Request for Class II Permissive Change

FCC ID: 2ARF9CSG-BT
Date of Grant: 10/08/2019

FCC- C2PC-Cover Letter

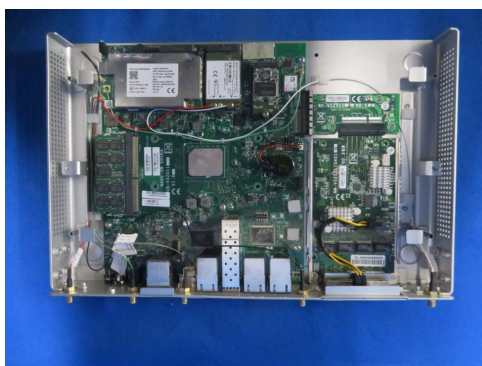
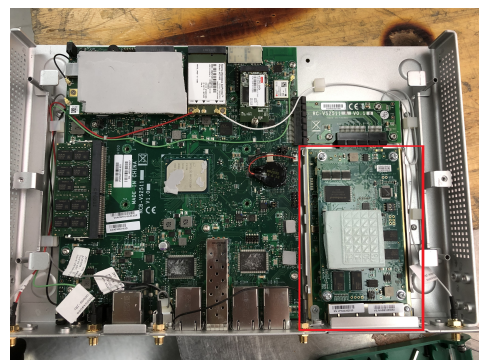
1. Versa Cloud Services Gateway CSG700 series provide one slot for optional Network Interface Card (NIC). CSG700 series already including a NIC-4GP card to provide 4 ports electrical GE interface and support 802.3at POE. Versa Networks also develop several kinds of new NIC to replace the NIC-4GP card for different customer deployments as below:

- NIC-4GP-120W
 - NIC-4GP-120W provide 4 ports electrical GE interface, and support 803.3bt PoE, single port supports up to 60W, and total 4 ports support up to 120W.
- NIC-4GF
 - NIC-4GF provide 4 ports optical SFP GE interface.
- NIC-8GE
 - NIC-8GE provide 8 ports electrical GE interface.
- NIC-4DS
 - NIC-4DS provide 4 ports T1 interface.

2. The RF part of the product is exactly the same, but the NIC is different.
